ADDENDUM NO. 2:

Date:	June 30, 2015
Project:	Alberta Technology Center
Owner:	The City of Tuscaloosa
Owner's Project No:	A15-0513
Architect:	Ward Scott Architecture, Inc.

This Addendum forms a part of the Contract Documents and modifies the original Bid Documents dated June 22, 2015, as noted below.

AC03

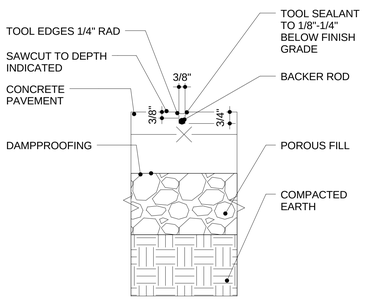
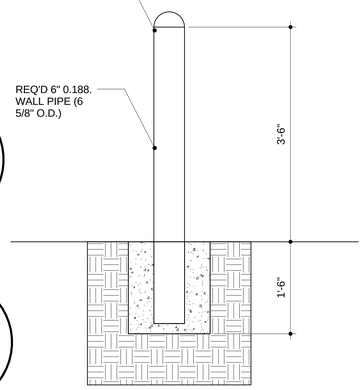
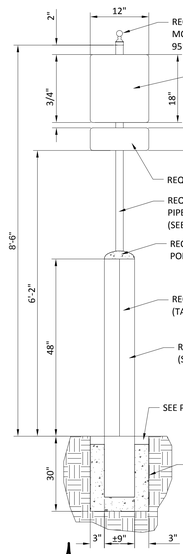
2. Refer to Sheet AC03 Site Plan Details, Detail 3 has been replaced.
   3. Refer to Sheet A104 Upper Roof Plan
      a. Lightning protection system has been updated to reflect connection thru building to lower roof

2 DETAIL - PREFAB CANOPY - TYP
1 1/2" = 1'-0"

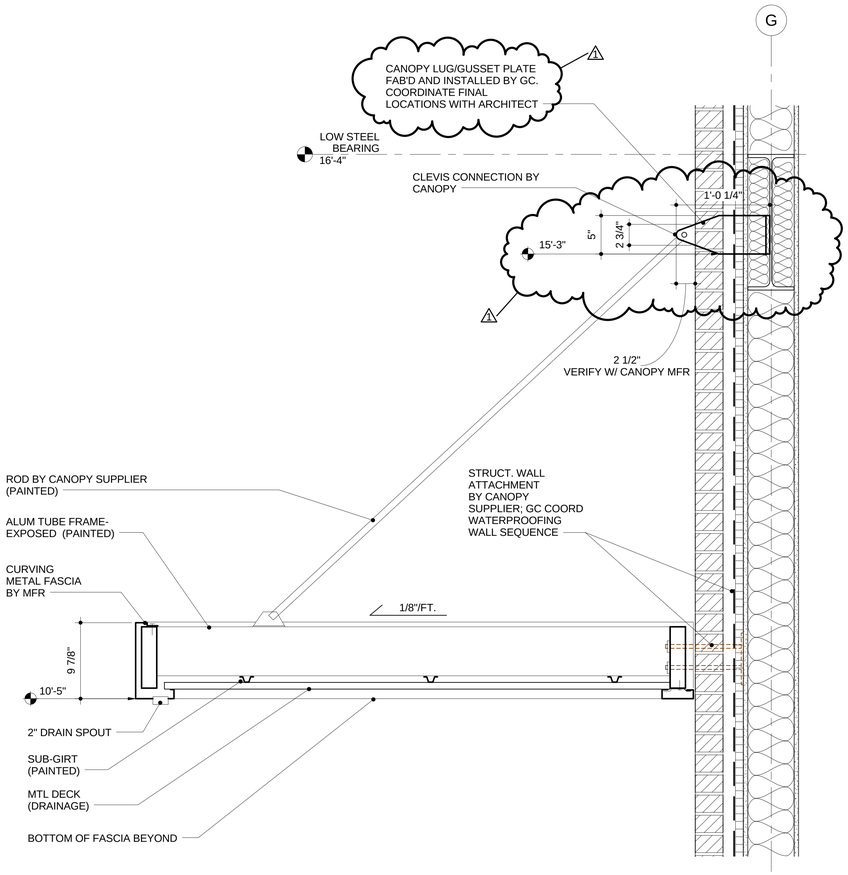
4. Refer to Sheet A105 Canopy Plan and Details
      a. Detail 2 - Gussett/Lug note and dimensions have been added
   5. Refer to Sheet A111 Enlarged Floor Plan

1 DETAIL AT CURVED ROOF (UPPER)
3" = 1'-0"

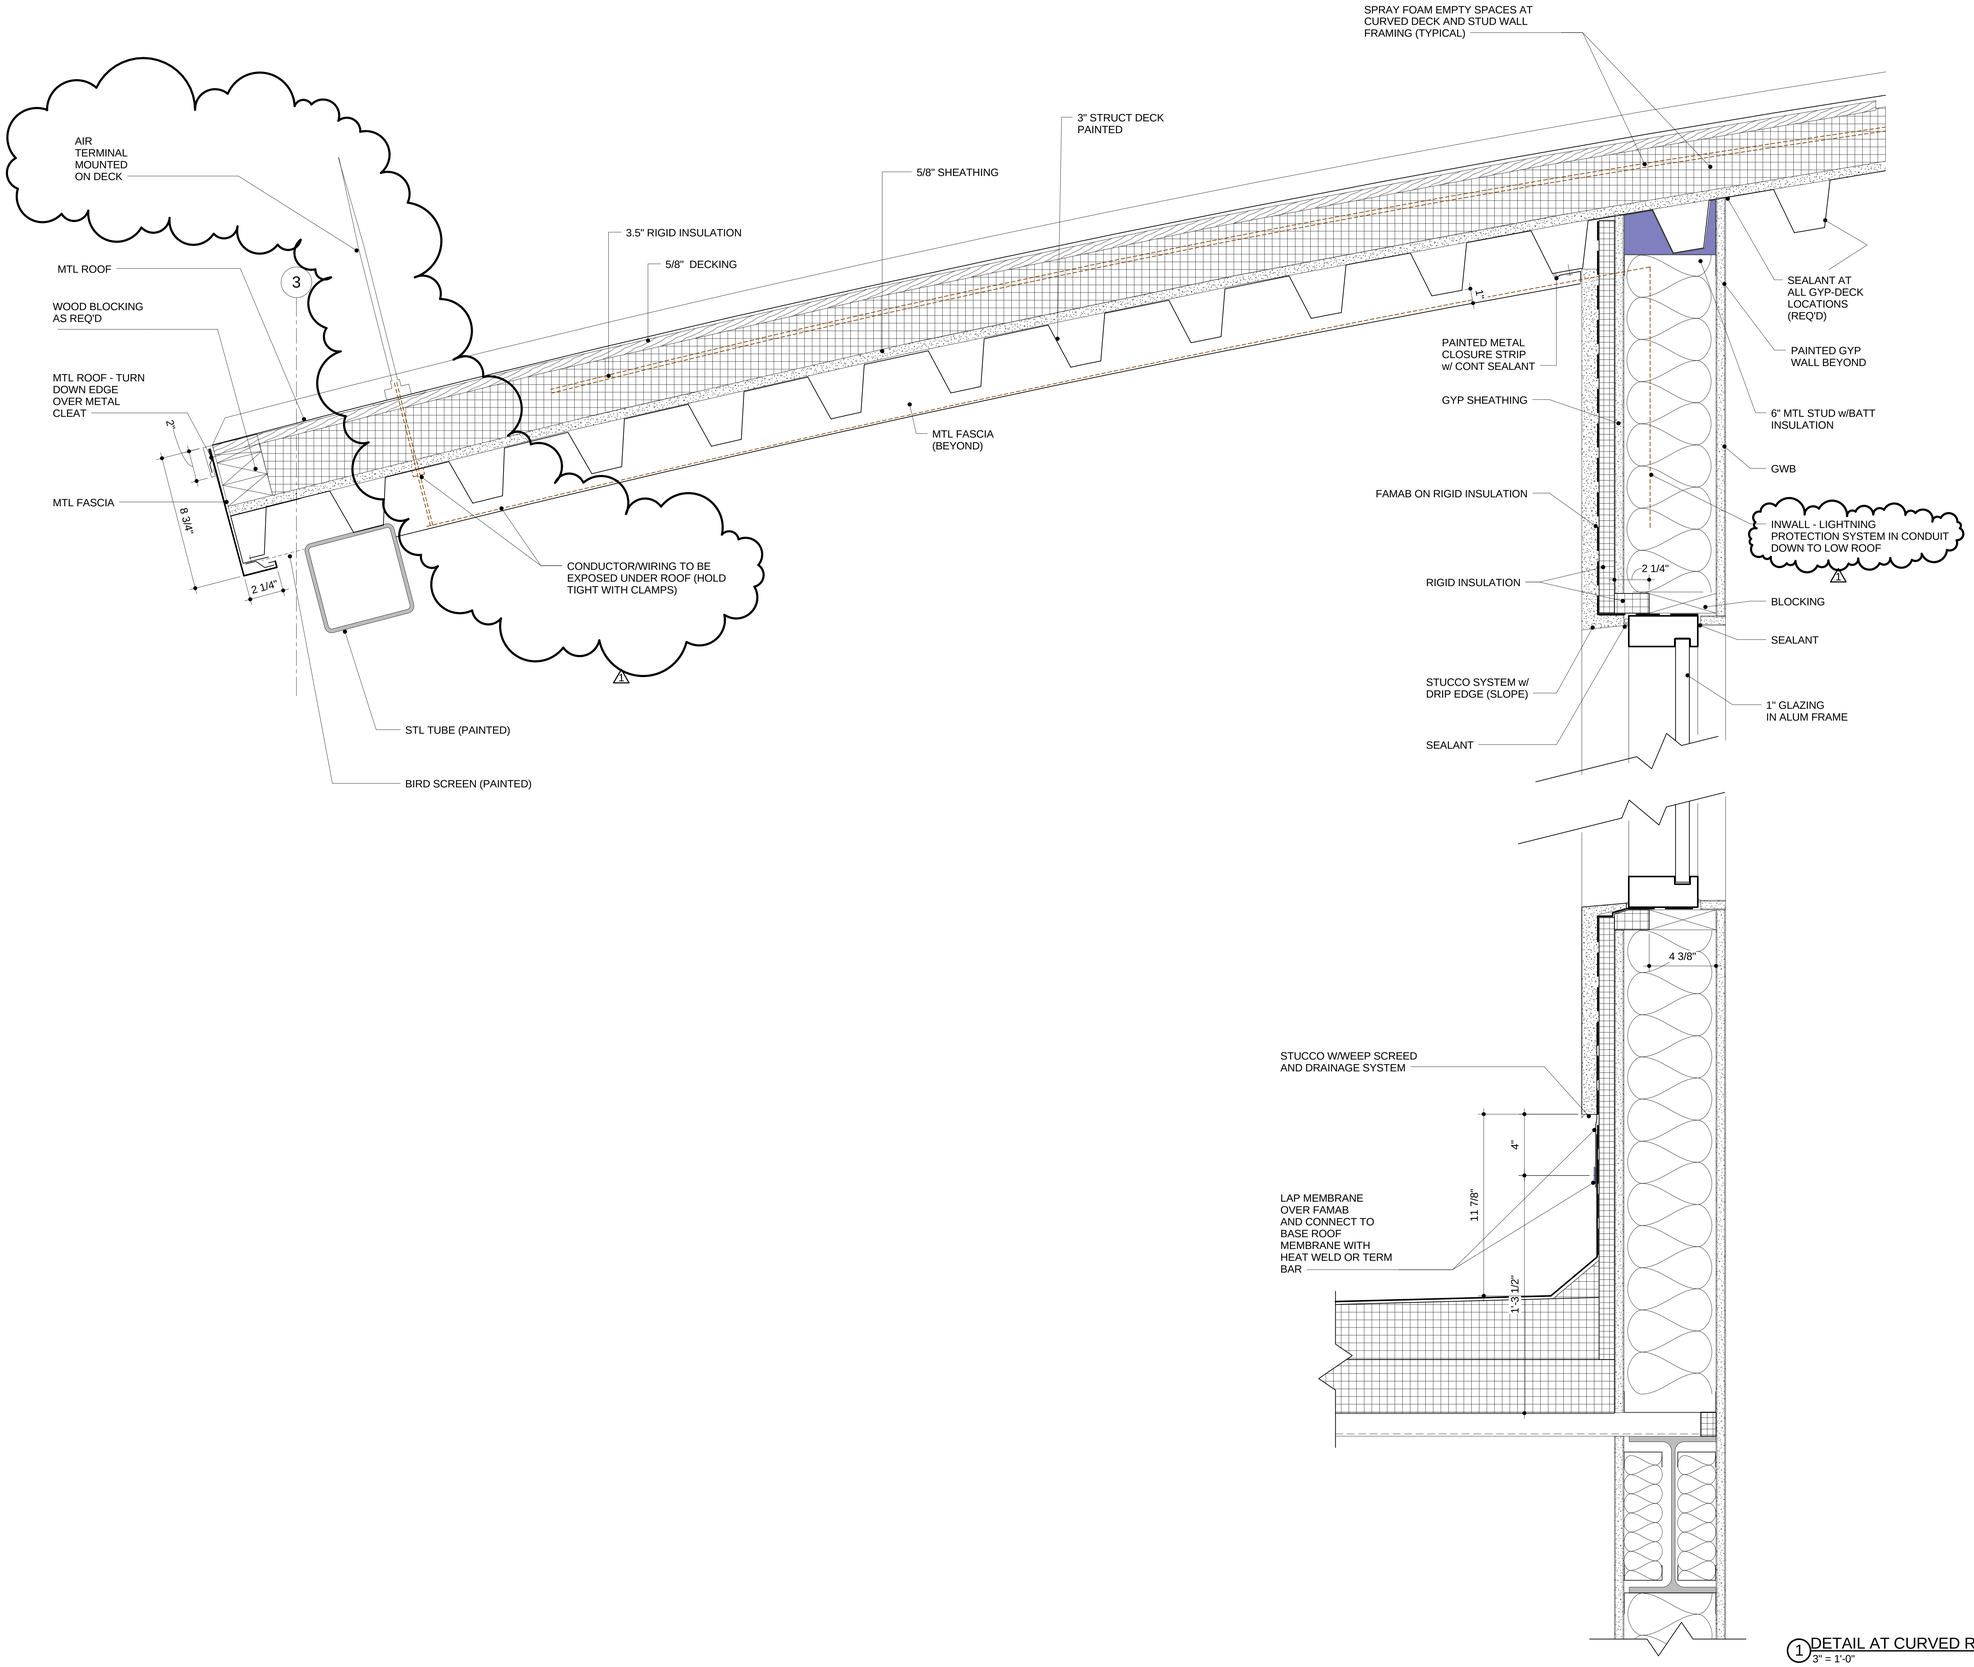
7. Refer to Sheet A312 Details Curved Roof
      a. Detail 1 - Lightning protection system has been updated to reflect connection thru building to lower roof

1 WALL SECTION - CLERESTORY WINDOW
1 1/2" = 1'-0"

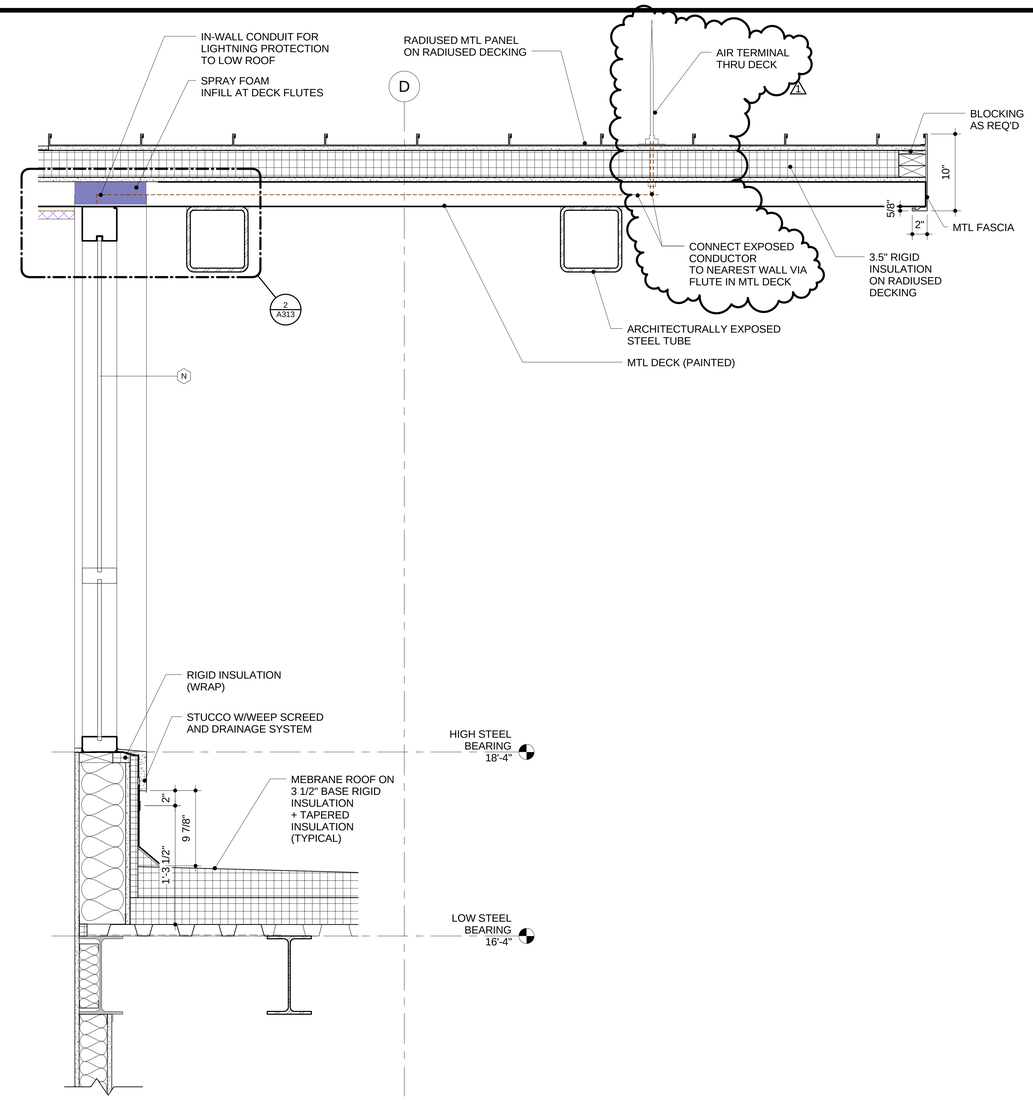
8. Refer to Sheet A313 Details Curved Roof
      a. Detail 1 - Lightning protection system has been updated to reflect connection thru building to lower roof

4 DETAIL @ WINDOW (CAST STONE SILL)
3" = 1'-0"

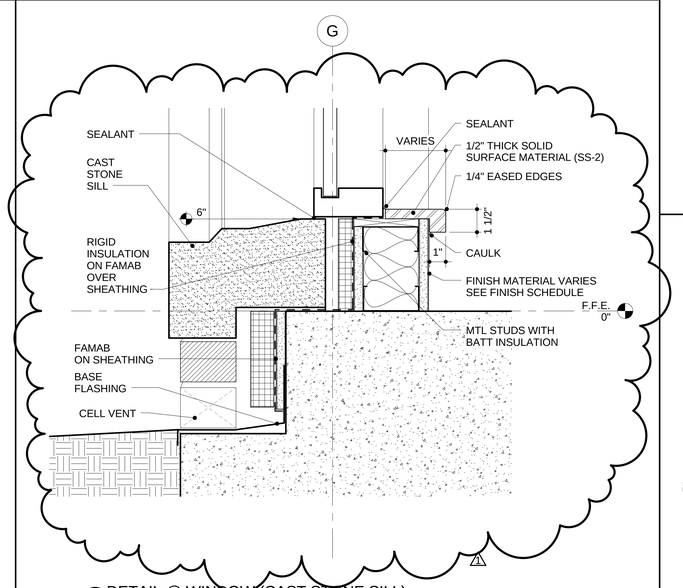
10. Refer to Sheet A331 Section Details
      a. Detail 4 – solid surface sill and lip shown.
   11. Refer to Sheet A332 Typical Details
      a. Detail 9 (New) – add ¾" x 2" painted wood wall trim
